0054
United States Department of the Interior

BUREAU OF LAND MANAGEMENT
Moab District
P. O. Box 970
Moab, Utah 84532

Re: Deer Creek Mine Resource Recovery and Protection Plan
(R2P2) Modification, 1st and 2nd Left Longwall Panels

ORIGINAL MINE MAP
ENCLOSURE 1

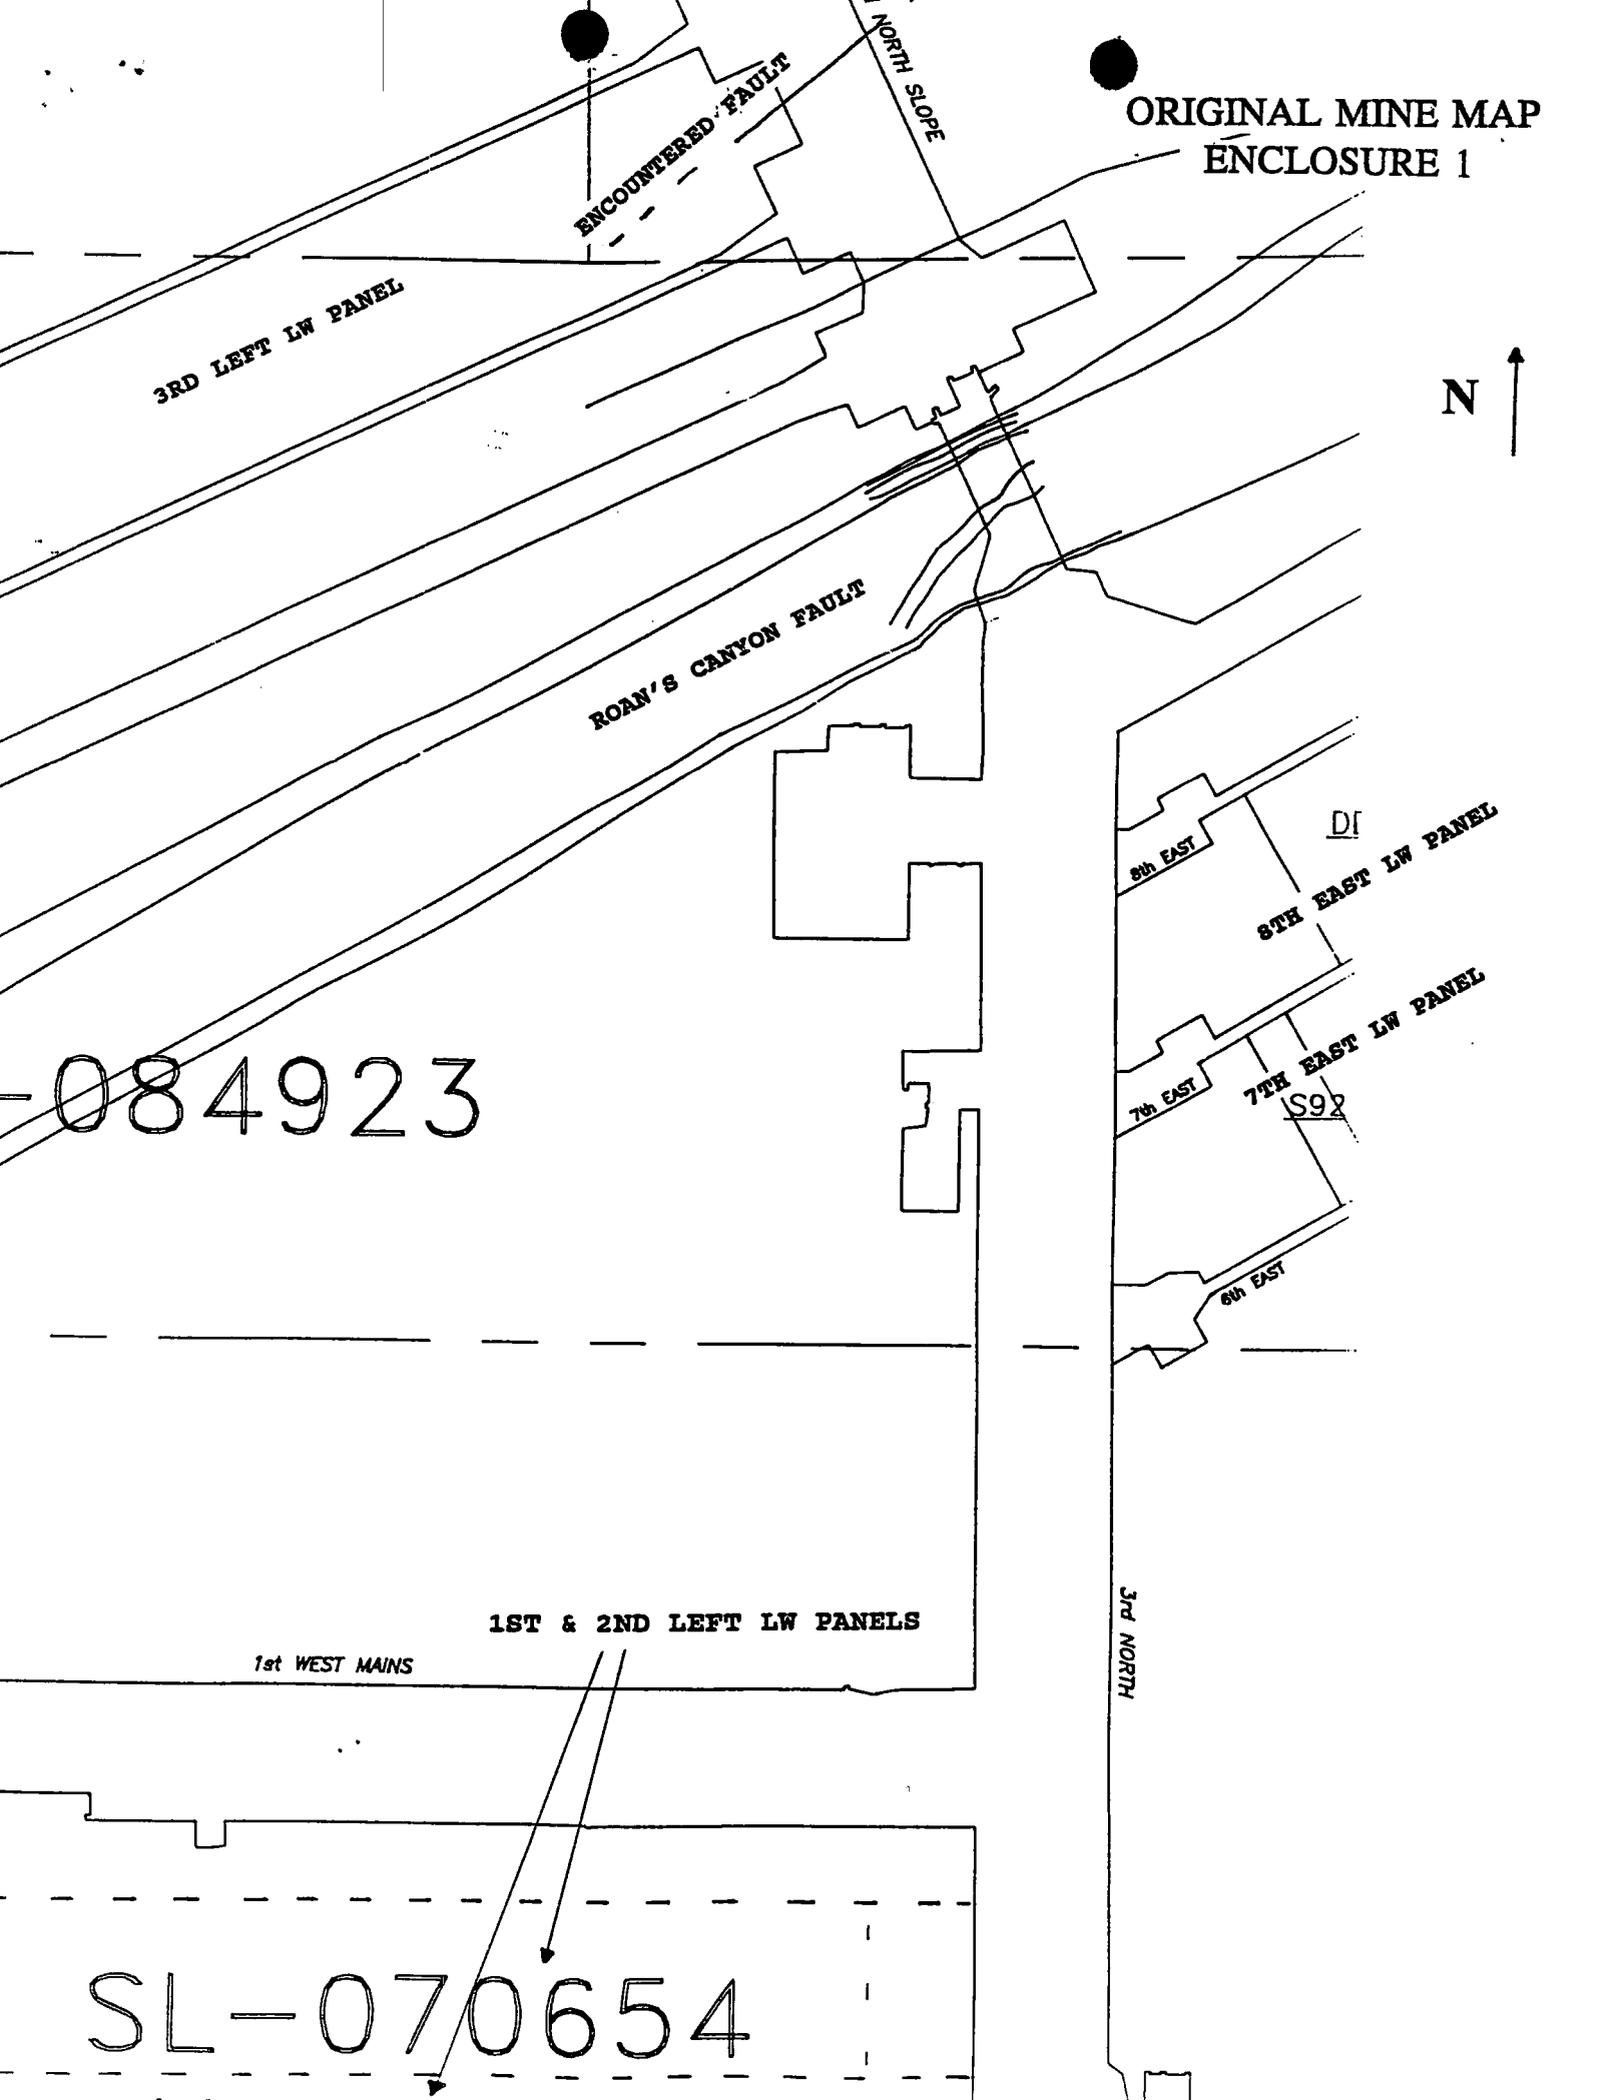
PacifiCorp requests to mine in sequence the following longwall panels: 7th East, 8th East, 2nd Left and 1st Left. The originally approved R2P2 had the first longwall panel on the north side of the Roan's Canyon Fault, named 3rd Left off 3rd North Slope, to be mined after the 7th and 8th East panels (see Enclosure 1). The 2nd and 1st Left longwall panels, located between 1st West Mains and Old Main West, were originally planned to be mined at the end of the mine life, but now are to be mined after the currently planned 7th and 8th East panels.

The proposed modification states that the 3rd North Slope has encountered a projected fourth fault of the Roan's Canyon Fault system with an unexpected large displacement. This will delay development of longwall panels in this area until this fault has been delineated and crossed. PacifiCorp states that mining the 1st and 2nd Left panels now will allow time to cross the fault and assure continued coal production from the mine.

A slight change from the original panel layout was noted in the submitted modification. The gate entries for the 1st and 2nd Left longwalls will now be mined west off a new set of access entries named 3.5 North. This access entry set would be driven south from 1st West Mains into the barrier between 3rd North and the longwall panels. The original plan had the longwall gate entries driven directly off 3rd North (see Enclosure 2). The BLM agrees with the new plan in that the 3rd North ventilation layout would be left intact with no extra overcasts and the 3.5 North access entries would be mined in the barrier, not reducing the panel length. This is a more efficient layout for the long-term ventilation use of 3rd North.

The BLM has determined that the proposed modification is in compliance with the Mineral Leasing Act of 1920, as amended, the regulations at 43 CFR 3480, the lease terms and stipulations, and will achieve maximum economic recovery of the Federal coal. The sequencing change of the longwalls off 3rd North is approved.
